Intel[®] DBPXA250 and DBPXA210 Development Platform for Intel[®] Personal Internet Client Architecture

Specification Update

July 2002

Order Number: **278555-002**

Figure 3. LCD Picture 1

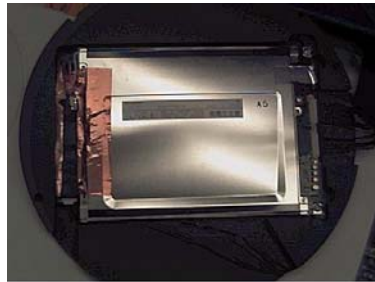
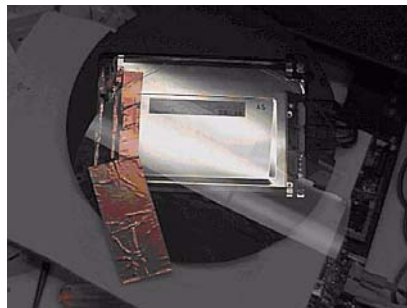
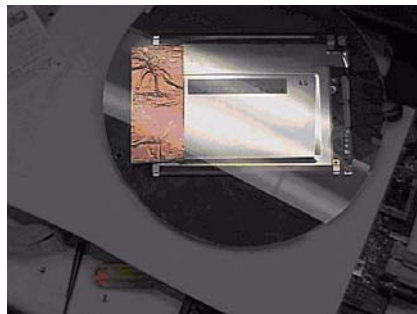
14. LCD Touch Screen Intermittently Fails

Problem: LCD screen is open to excessive noise disruption on the touch screen.

Implication: Excessive noise disruption reduces LCD screen display quality. The touch screen may not work correctly.

Workaround: Fix this problem by covering the back light inverter with copper foil shielding tape to decrease the electrical noise transferred to the LCD and Touch Screen.

1. Disassemble the BBPXA2xx development baseboard touch screen enclosure.
2. Remove the back light inverter.
3. Cut a piece of heat shrink tubing (1"x3") and place over the inverter.
4. Heat the tubing until it collapses on the inverter.
5. Cut a 2"x5" piece of copper tape and place on clear plastic disk covering the inverter. The adhesive side should face the plastic.
6. Cut a 2"x5" piece of copper tape and place on the black plastic disk under the inverter. The adhesive side should face the back of the LCD metal enclosure.
7. Reassemble the touch screen enclosure.

Figure 6. R9 Pad to C29

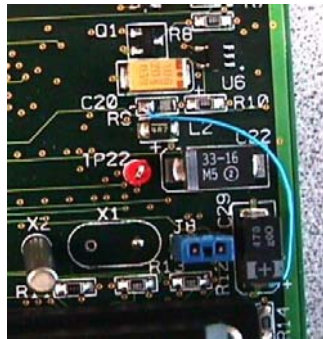
3. VCC_PLL And VCC_CORE Pin Voltage Must Be Equal

Problem: The Intel® PXA250 and PXA210 Application Processors Developer's Manual states VCC_PLL requires VCC_CORE voltage instead of a separate voltage supply.

Implication: The PXA250 processor may not work if VCC_PLL is not equal to VCC_CORE.

1. Remove R9.
2. Add a 30-AWG wire from the R9 pad (inductor L2 side) to the positive side of C29. This can be done on the top of the board.

Figure 7. Wire From The J3-3 To The Via Of U1 Pin 1

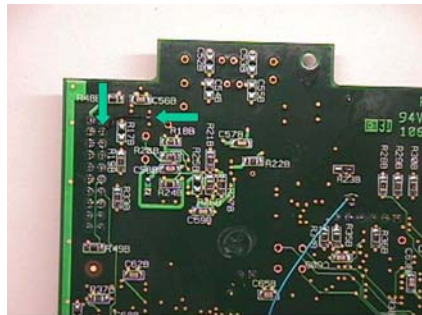
7. For ARM® Multi-ICE® JTAG Use

Problem: JTAG connection fails when using ARM Multi-ICE tools.

Implication: No JTAG debugging facility is available with ARM Multi-ICE.

1. Cut the trace on the top of the processor card between U1 pin 3 and via to the right.
2. Add 30-AWG wire from the J3-3 to the via of U1 pin 1 on the bottom of the processor card.

3. Add a 30-AWG wire from J3-2 to +3.3 V.

Figure 9. Voltage Divider

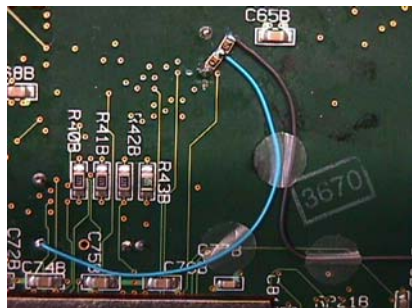
8. Excessive Oscillator Output Voltage to PEXTAL Pin

Problem: On systems using an oscillator to drive PEXTAL, the 3.3 V output from the oscillator is too high.

Implication: Possible damage to chip.

Note: These steps bring the oscillator voltage down to 1.1 V. The oscillator and core voltages need to be equal.

1. Attach one side of a 430-ohm resistor to the bottom (on the bottom of the processor card) of TP19 (ground).
2. Attach a 30-AWG wire from the remaining side of the 430-ohm to crystal X1 (The pin closest to the edge of the board).
3. Attach one side of a 620-ohm resistor to the junction of the wire and the 430-ohm resistor. The two resistors will “sandwich” the wire going to X1.
4. Attach another 30-AWG wire from the +3.3 V oscillator output (bottom of U7) to the open end of the 620-ohm resistor.

Figure 11. U10B Trace Cut Pin 38

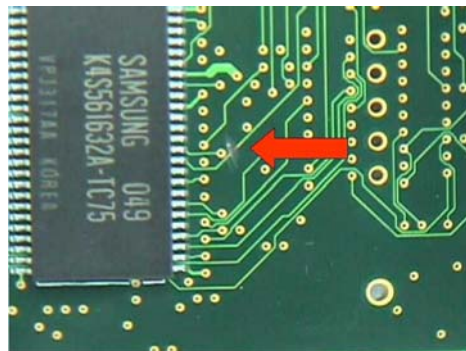
10. Signal Integrity Problems On SDCLK

Problem: Signal integrity problems on SDCLK.

Implication: Unstable operation with 100-MHz SDCLK.

1. Cut the trace exiting U10B, pin 38 on the bottom of the DCPXA250 processor card.
2. Update CPLD U4 with latest code. Refer to <http://developer.intel.com> for latest CPLD updates. This adjusts the voltage (VCC) from +1.2 V to +1.4 V.
